RCA-78-23-004-1: Replace Door Mid Woofer Speakers and Fasteners

Document Type	Customer Satisfaction Campaign Bulletin
Date	April 25, 2023
Affected Region(s)	USA
Affected Model(s)	R1T
Model Year(s)	2022
Approximate Build Dates	October 2021 - December 2021
 Refer to Open Containments in ServiceOS to determine if this document applies to a specific vehicle.	
Vehicle System	78 - Low Voltage Electrical
Minimum Service Location	Mobile

**Note:** Front shown, rear similar.

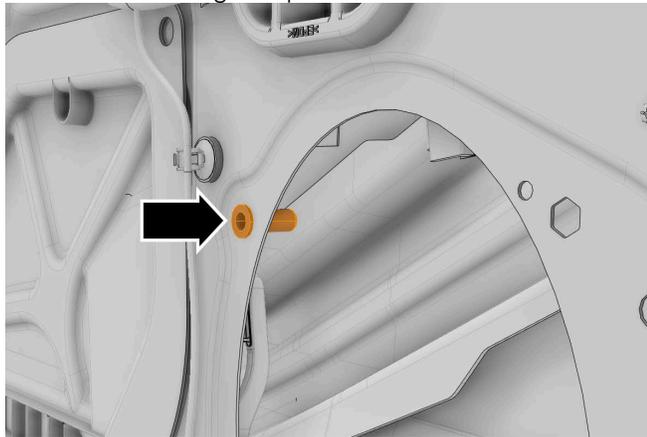
1. On both sides: Remove: Speaker, Mid Woofer, Front Door, LH (refer to service manual procedure 784630010).
2. On both sides: Remove: Speaker, Mid Woofer, Rear Door, LH (refer to service manual procedure 784632010).
3. In 4 locations:

b. In 4 locations: Using the special tool: Install:

4. On both sides: Replace: Speaker, Mid Woofer, Front Door, LH (refer to service manual procedure 784630010). Use new fasteners.
5. On both sides: Replace: Speaker, Mid Woofer, Rear Door, LH (refer to service manual procedure 784632010). Use new fasteners.
6. Reinstall all components that were removed for access and replace all non-reusable components. Refer to the service manual procedures referenced in this document for additional component reusability information and torque specifications.
